DRB Application No.: 11DRB-70252 , Project # 1005354
Project Name: ARBOLEA DE VIDA + SAUNDYLL VILLAGE UNIT 2B
Agent: DEKKER PERICH SABATINI Phone No.:

DRB Application No.: <i>11DRB- 70265</i>	Project # <i>1005354</i>
Project Name: <i>Arbolera De Vida Unit 2B. Sawmill Village</i>	
Agent: <i>Dekker Perich Sabatini</i>	Phone No.:

**Re: Reason for Request
Sawmill Village
Request for Amended Site Development Plan for Subdivision
Tract 2-D of the Arbolera de Vida Subdivision, Albuquerque, NM (Phase 2)
Project # 1005354; 07EPC-00109**

11DRB-70265 MAJOR – SITE DEVELOPMENT PLAN FOR BUILDING PERMIT

1 LANDSCAPE PLAN ENLARGEMENT
PHASE II

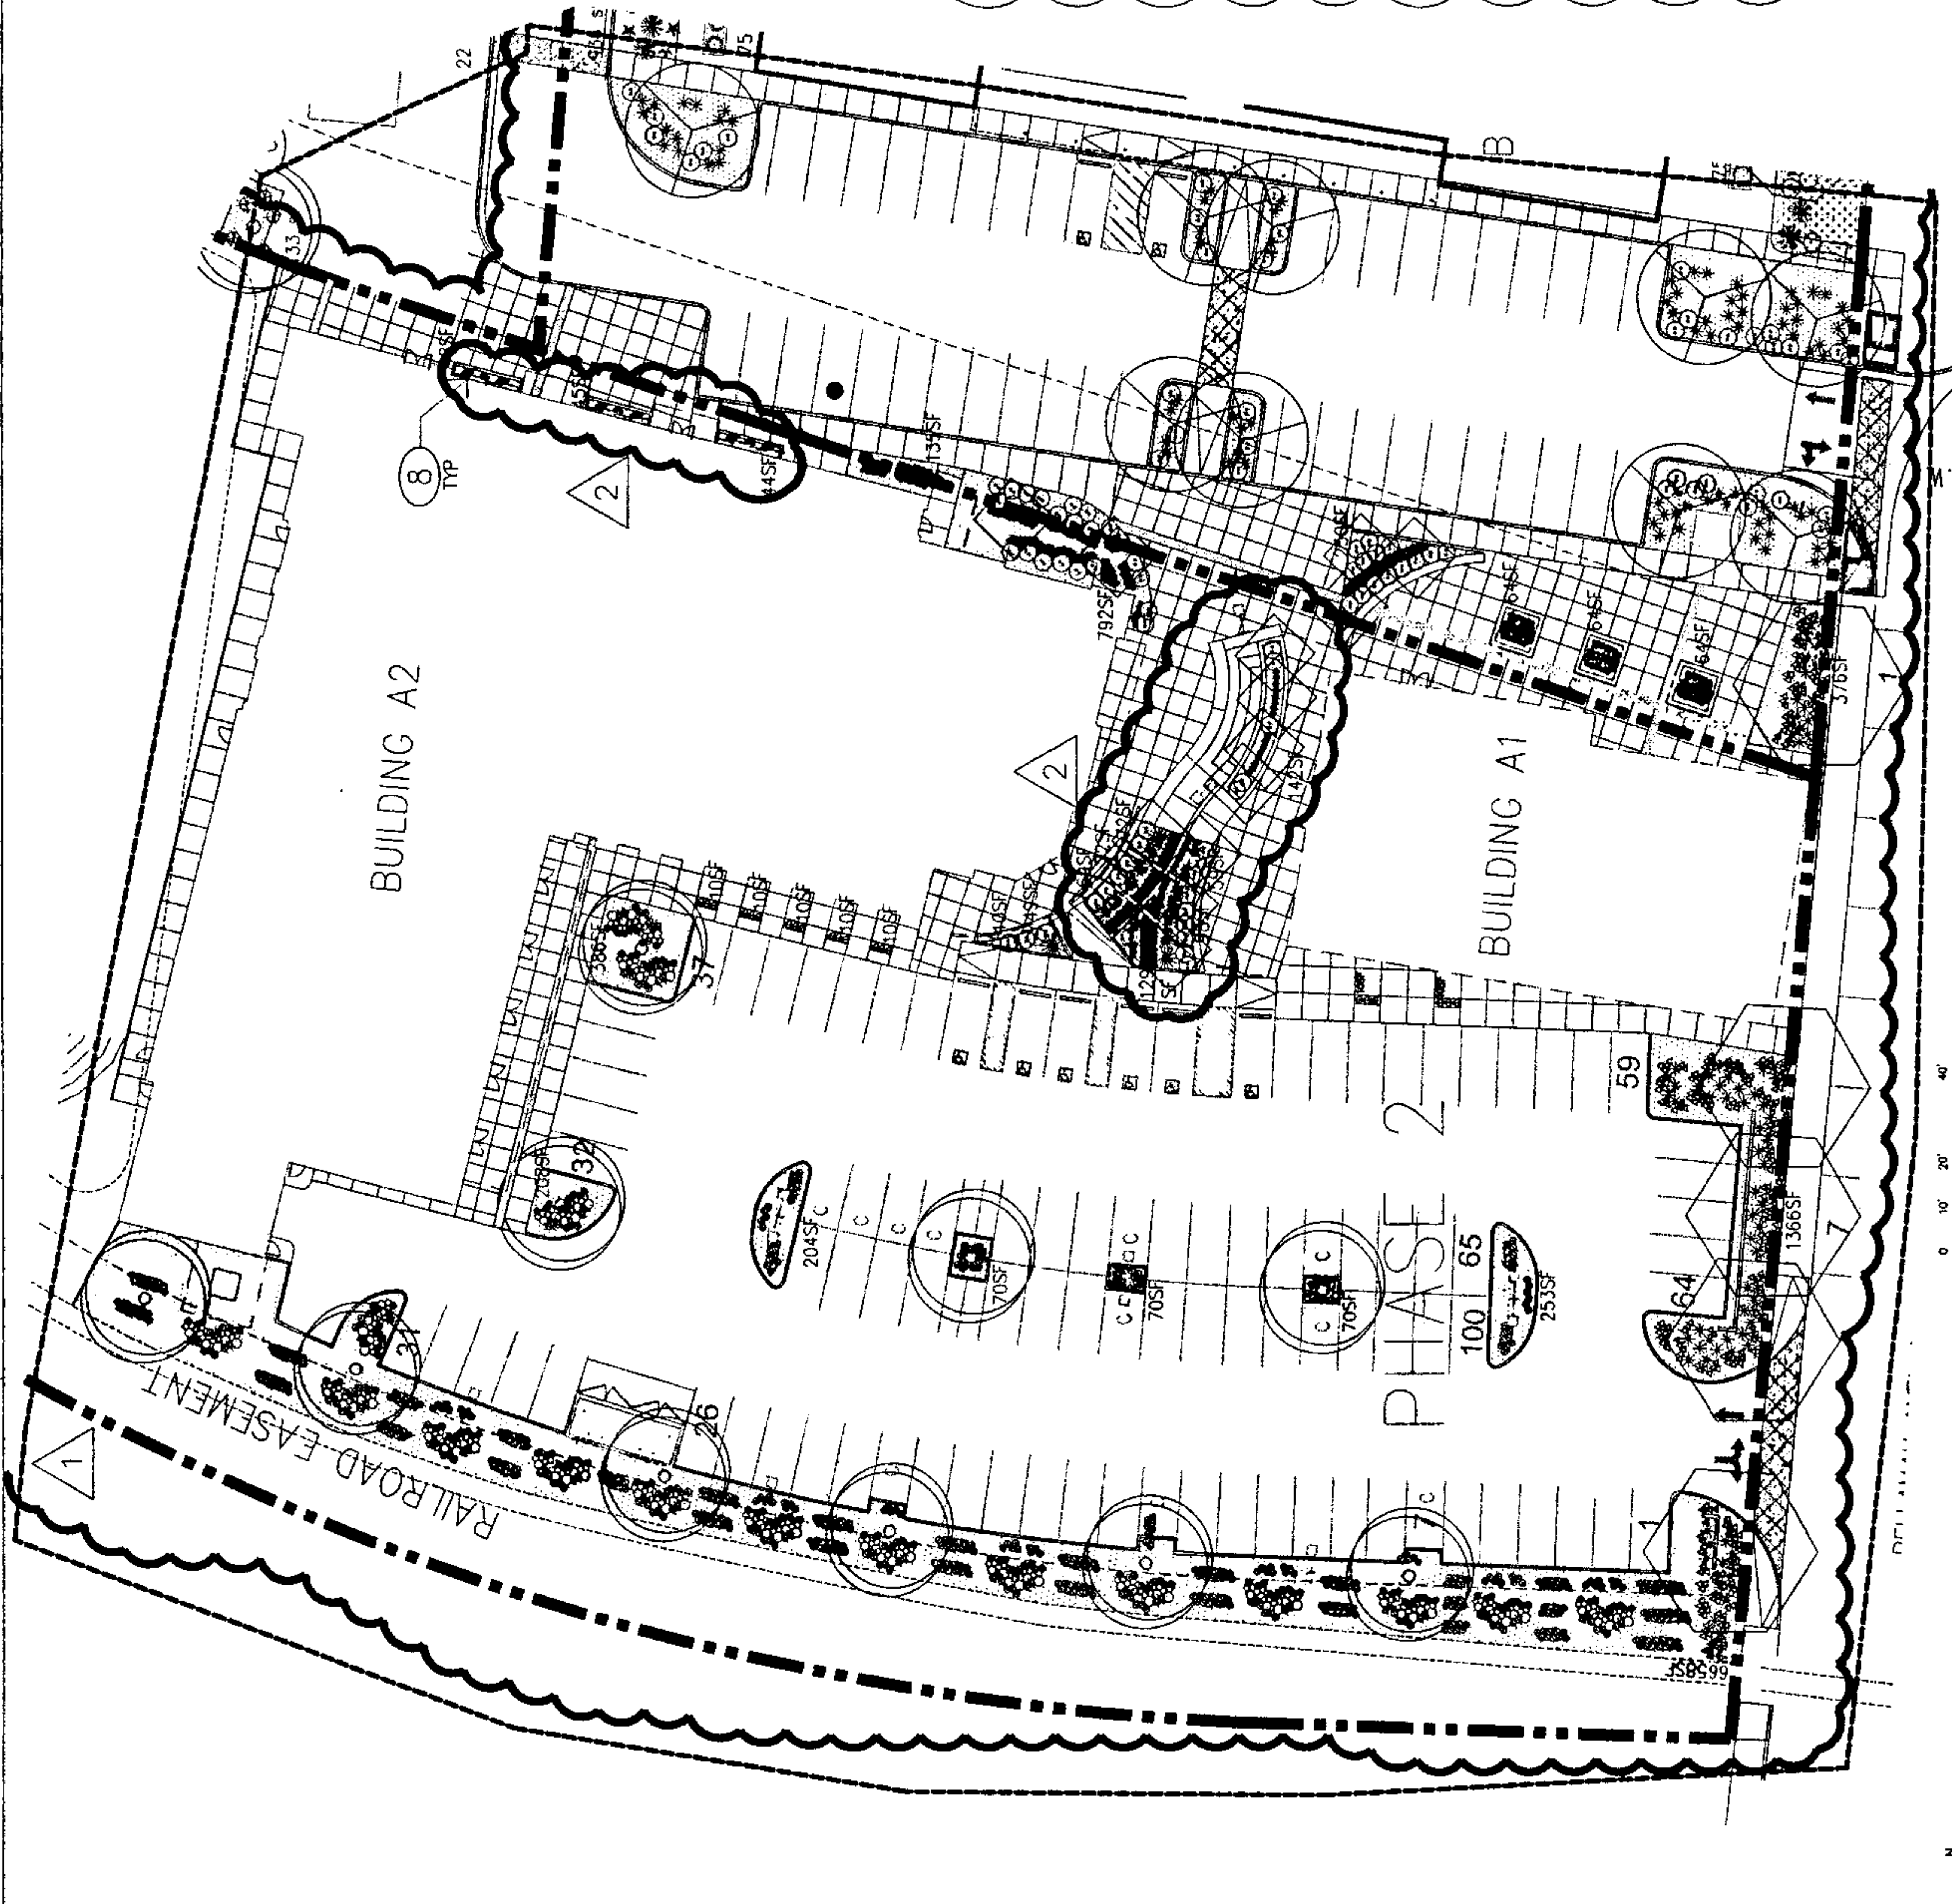
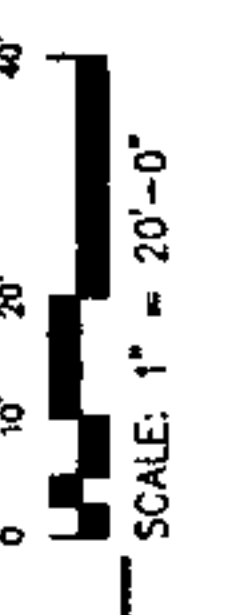
- c. The seat walls around the planters shall be shown.

Please change Keyed Note 5 on the Landscape Plan, by removing the word "Proposed".

RESPONSE: The seat walls are shown and indicated by note 8 on SDP2 and SDP2A.
